Attached to Conservation Groups'
May 27, 2011 Public Comment Letter
Submitted in EIB 11-01 (R) and EIB 11-02 (R)

Re: New Mexico Environment Department, Air Quality Bureau May 3, 2011 Public Meeting in Farmington on the proposed Regional Haze state implementation plan revisions and proposed revisions to the good neighbor provisions of New Mexico's infrastructure state implementation plan. The New Mexico revisions include a determination of Best Available Retrofit Technology for San Juan Generating Station.

I have been asked by counsel to provide technical comments on the proposed NOx Best Available Retrofit Technology (BART)[1] determination proposed by the EPA[2] for Units 1-4 at PNM's San Juan Generating Station (SJGS).

In addition, the figures below show the 30-day rolling average data for each unit.

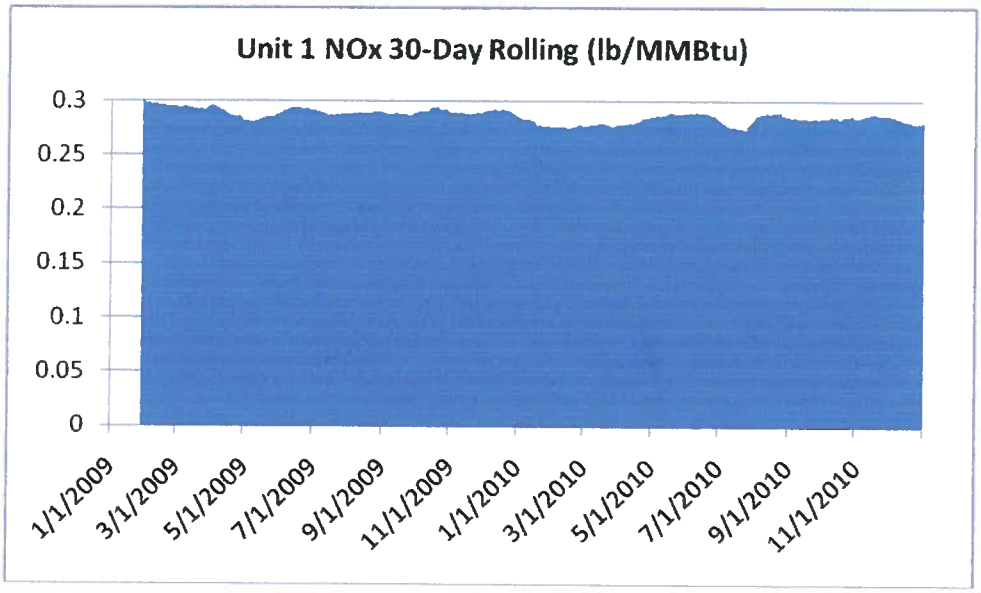
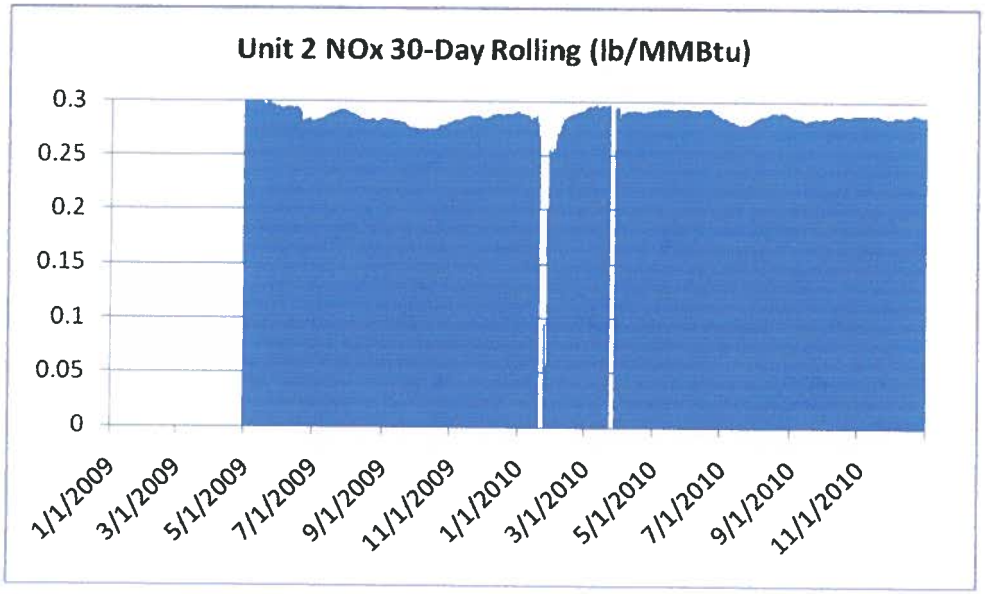
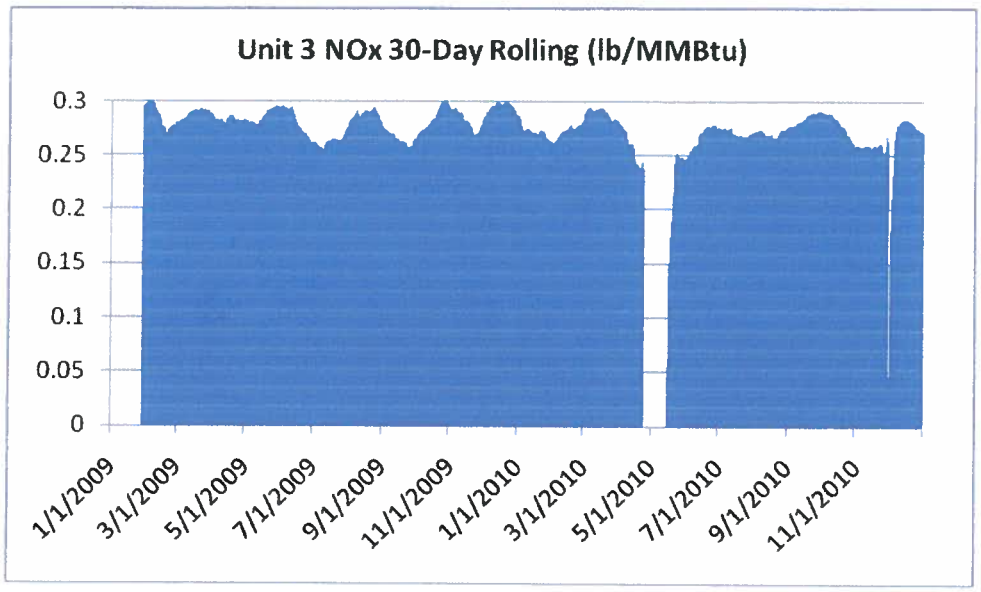
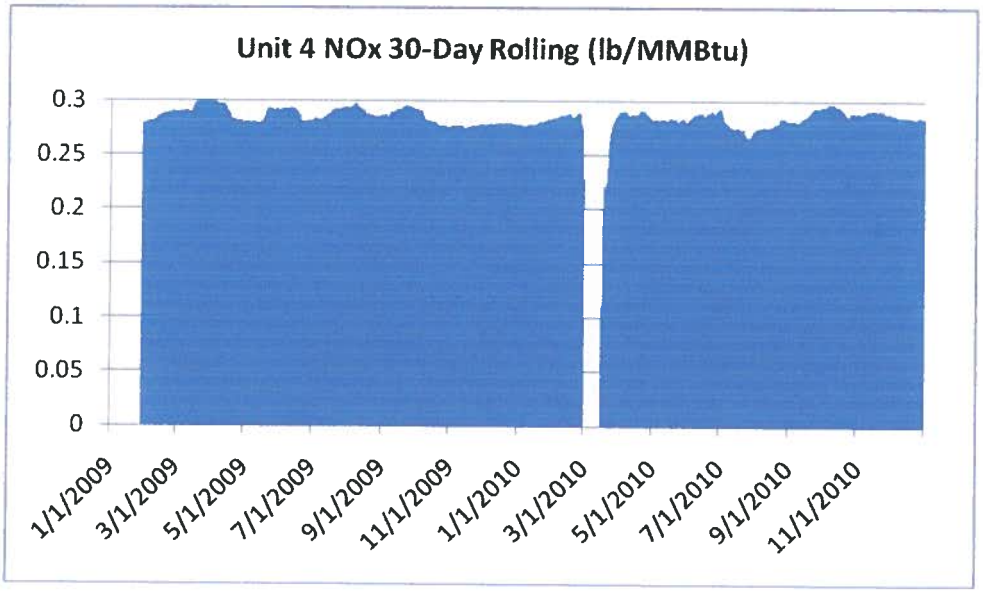
Based on the above, it is clear that: (a) for each unit, the average of the 30-day rolling average NOx did not exceed 0.29 lb/MMBtu; and (b) while there is expected variability in the 30-day rolling average values, this variability is not excessive. For example, the ratio of the maximum (of the 30-day rolling average values) to the average, is below 12% is all units. It ranges from a low of 4.7% for Unit 1 to a high of 11.1% for Unit 2. For purposes of this discussion, I will

assume that the baseline NOx emissions for any of the four units is 0.29 lb/MMBtu.[7] Based on the fact that NOx emission rates from all 4 units are so similar, and that the 30-day average NOx values are only slightly below 0.30 lb/MMBtu for each unit, it appears that all 4 units are being operated in a manner that will ensure only minimum compliance with the Consent Decree (rather than achieve the lowest NOx rate possible). It is my opinion, as I will discuss next, that the boiler-out NOx emissions at SJGS could be somewhat lower. That said, I do not rely on lower boiler-out NOx emissions in my SCR discussion below. My analysis below assumes that boiler-out NOx rates are those shown in Table A above. But, to the extent the boiler out emissions can be lowered, it will simply provide additional compliance margin.

EPA's Region 8 Office has compiled a graphic presentation of SCR capital costs—please see Appendix B for "SCR References"

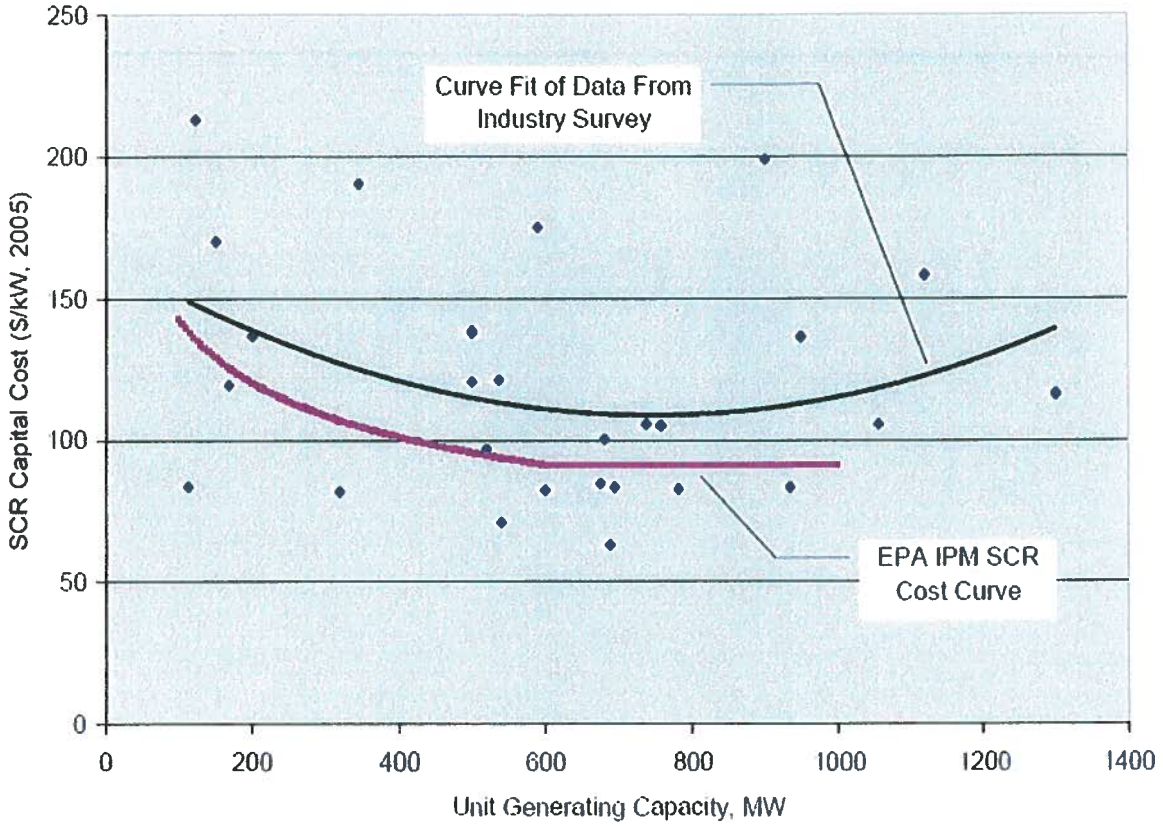
The EPA data confirm that SCR capital costs typically range from $73 – $243/kW. In comparison, PNM's cost estimates for SJGS appear to be overestimated.
